## Proposal to introduce new criteria on the automatic levelling of headlamps based on the GTB glare and visibility studies.

This paper provides additional explanation supporting the joint GTB / OICA proposal, GRE/2015/05 and also updates some of the content of the proposed amendments to Regulation No.48.

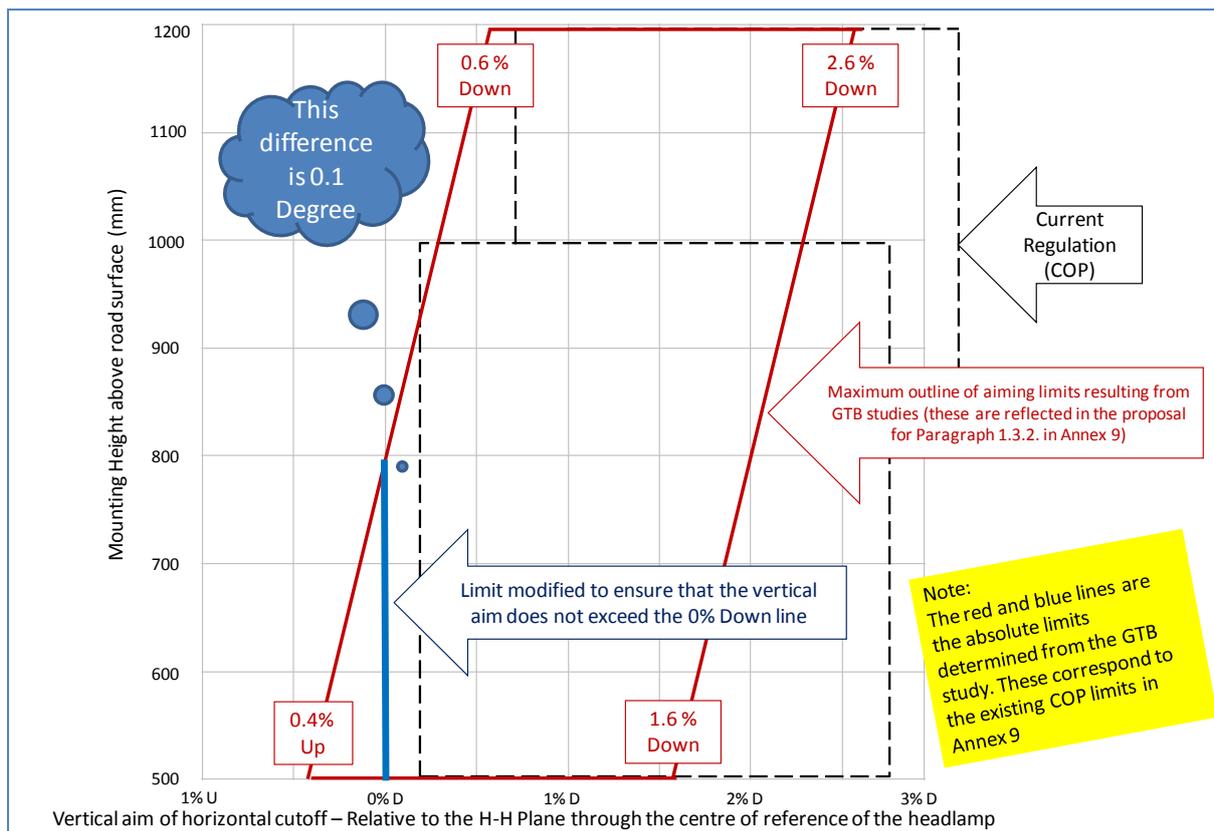
The paragraphs 13-17 of the justification of GRE/2015/05 provide a summary of the key points of the proposal to amend Regulation No.48. Figure 1 compares the proposed aiming limits with the current requirements of paragraph 6.2.6.1.2. However as the proposal relates to the absolute limits of aiming, for acceptable glare and visibility, these should be compared with the provisions in Annex 9, paragraph 1.3.2. The comparison then shows:

In summary, the joint GTB / OICA proposal introduces a criterion that is technology neutral and offers improvements in visibility range whilst retaining the existing control of the position of the cut-off in respect of glare. In the case that the vehicle characteristics, under the 50% loading condition, result in pitch angles that do not remain within the limits shown in the diagram shown above, there is a mandatory requirement to install automatic levelling. It is estimated that the proposed criterion will cover the loading conditions, under normal use, of around 90% of vehicles type approved to these new requirements. The remaining 10% of loading instances are corrected by means of the manual levelling system, or at the discretion of the manufacturer, by the installation of automatic systems. In the case of manual levelling, actions to improve driver awareness of its function will have to be considered to answer the concerns regarding misuse.
